PLANNING

Client: Rebecca Nichols
Drawing Number: **P404_109**
Drawing Title: **Proposed GF Plan**
Date: 24/04/2025
Scale: 1:100 @ A4

P404_ 128 Old Lansdowne Road

Proposed Ground Floor Plan

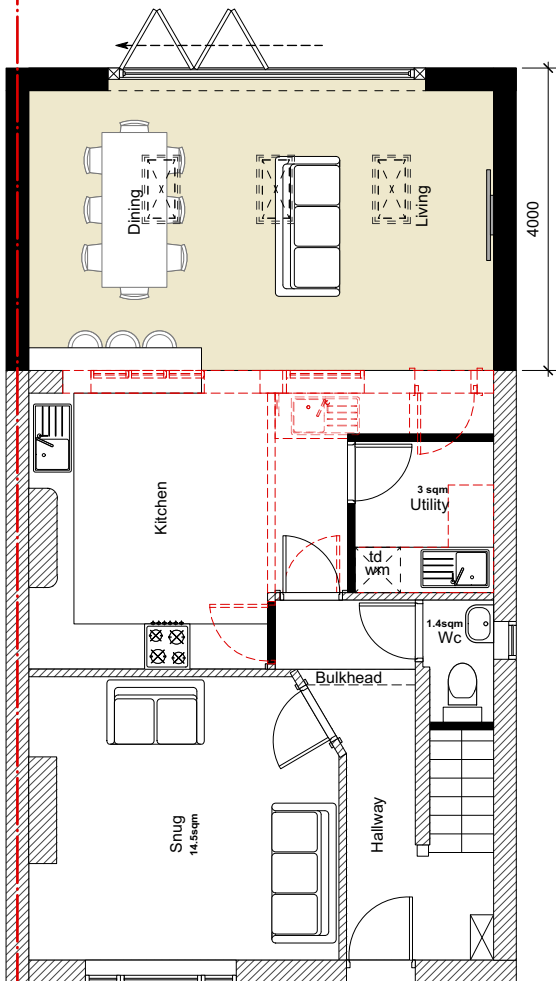
A 05/09/2025 Drawing status updated to Planning. Extension depth reduced to 4m in response to planner's comments dated 02.09.2025.
